Job No. 20111

**REQUEST FOR INFORMATION RESPONSE FOR
PROPOSED COMMERCIAL DEVELOPMENT
538 KARANGAHAPE ROAD, AUCKLAND CITY
BUN60427502**

Auckland Council have issued an RFI for the proposed development (dated 22 February 2024). The relevant information regarding 'Geotechnical Investigation', 'Groundwater' and S&RC's subsequent responses are provided below.

Figure 1: 582 Karangahape Road Southeast-Northwest (Source: Property File)

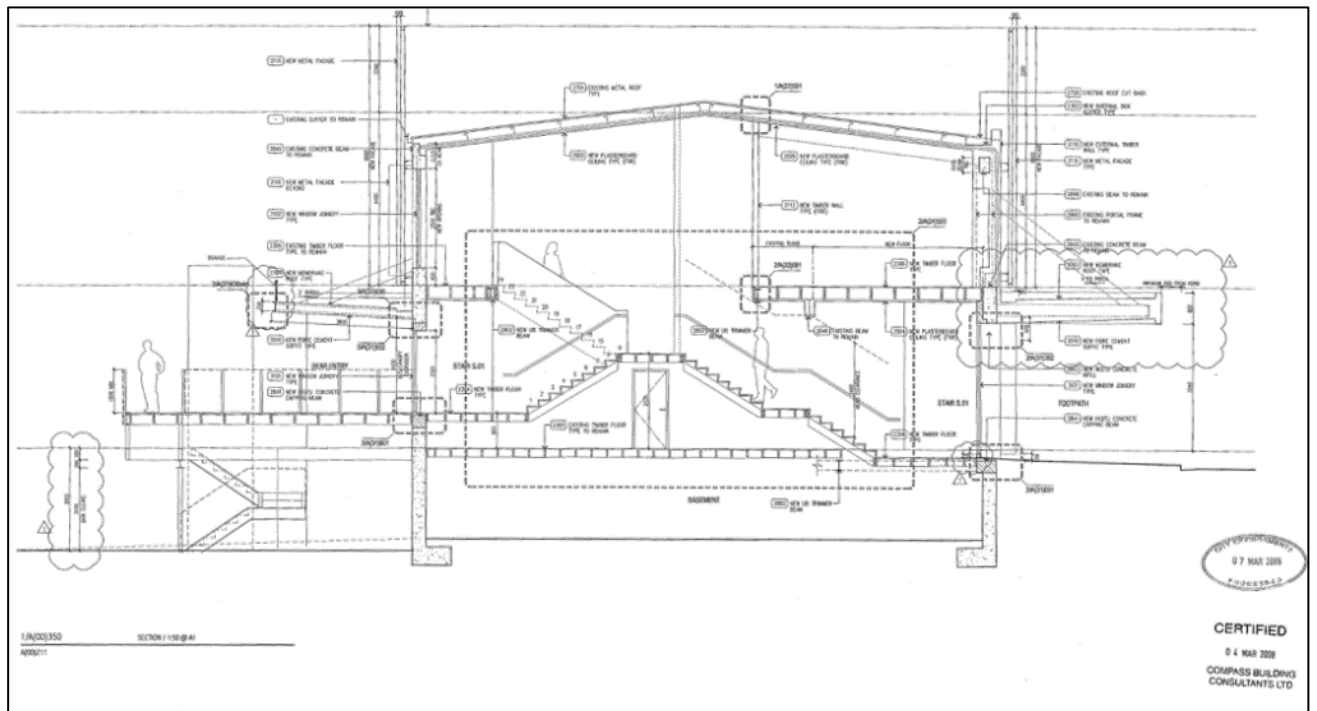
Please provide annotated drawings of the existing basement and foundations at 582 Karangahape Road, based on the property file records, which clearly demonstrate that Section C-C' is the critical section along the western boundary with a retained height of 5.8m.

Please refer to Figures 1 & 2 below. The retained height has been amended to 7.4m based on the site measurements of the No. 582 block wall embedment depth measuring 70.0mRL. The ground level behind the wall is below the basement of 68.4mRL however active earth pressure has conservatively been applied from underside of the block wall. As can be seen in the sketches, due to building's approximate boundary loading and with the remainder of the western boundary being asphalted carpark, Section C-C' is considered the critical section through the western boundary.
